Addendum #2

Bid Opportunity: 7198-RW-22 - Tait St. Public School

HVAC Renovations

MECHANICAL ADDENDUM

Title: **Unit Ventilator Controls**

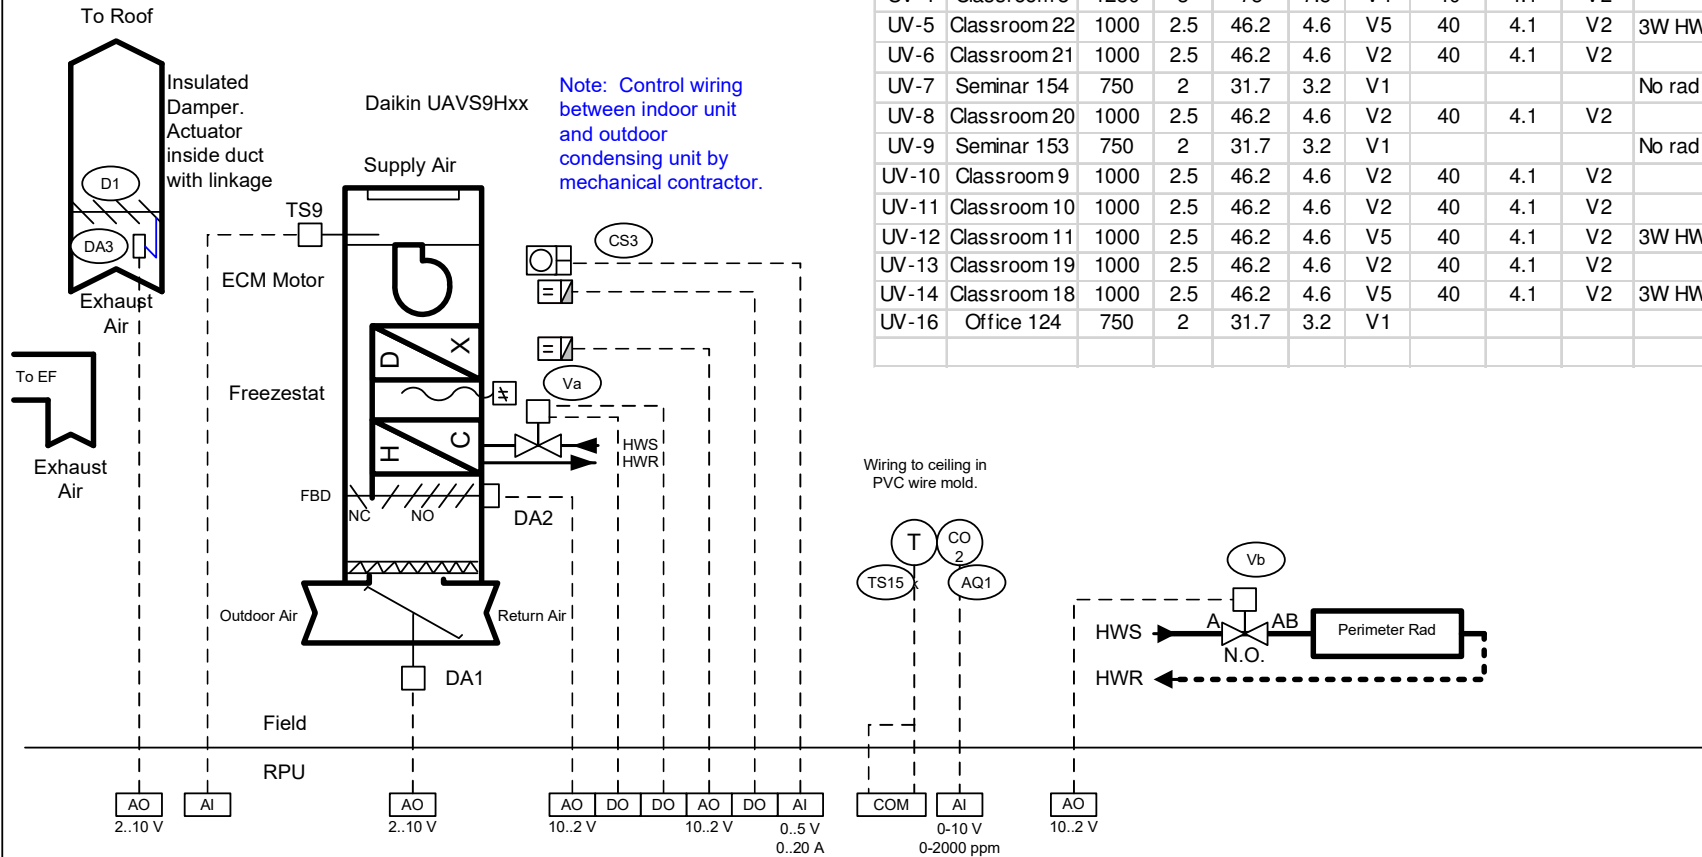
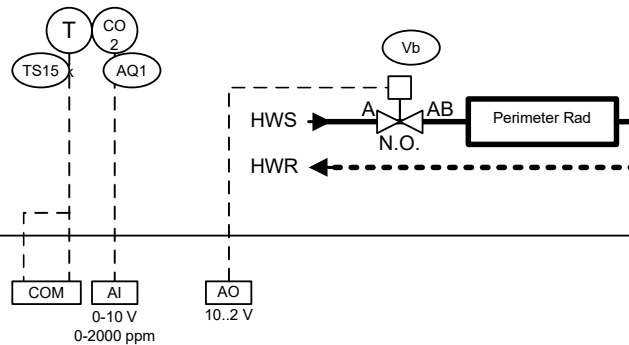
- .1 Revise Item 2.1.5.1 to include Carrier as an acceptable manufacturer.
- .2 Remove Item 2.1.6 "Equipment shall include terminal strip as indicated in sentence 2.1.14." Equipment shall not include on-board microprocessor controller.
- .3 Revise Item 2.1.6 to read as follows:
"Factory installed freeze stat wired to shut down fan and close outside air damper."

- .1 Item 4.2.1 reads as indicating that graphical sequence of operations will be provided by BAS contractor. This graphical sequence has been provided by the BAS contractor and is attached to this addendum.
